IEC 60601-2-10

AMENDMENT 1
2001-09

**Part 2-10:
Particular requirements for the safety
of nerve and muscle stimulators**

Figure 101 – Layout of testing arrangements (see 36.201.1.7 and 36.202.2.2d)

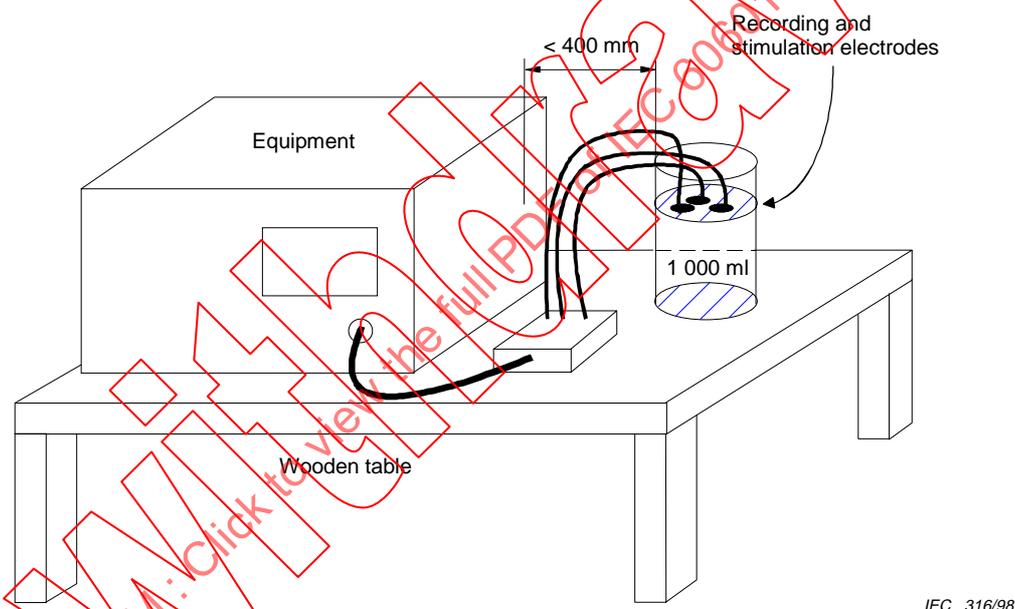
Replace the existing Figure 101 with the new Figure 101:

For the radiated radio-frequency emissions test, all relevant electrodes shall be connected and applied to the contents of a 1 000 ml capacity normal saline-filled phantom, positioned within 400 mm of the EQUIPMENT (see figure 101).

For the radiated radio-frequency electromagnetic field test, all relevant electrodes shall be connected and applied to the contents of a 1 000 ml capacity normal saline-filled phantom, positioned within 400 mm of the EQUIPMENT (see figure 101).
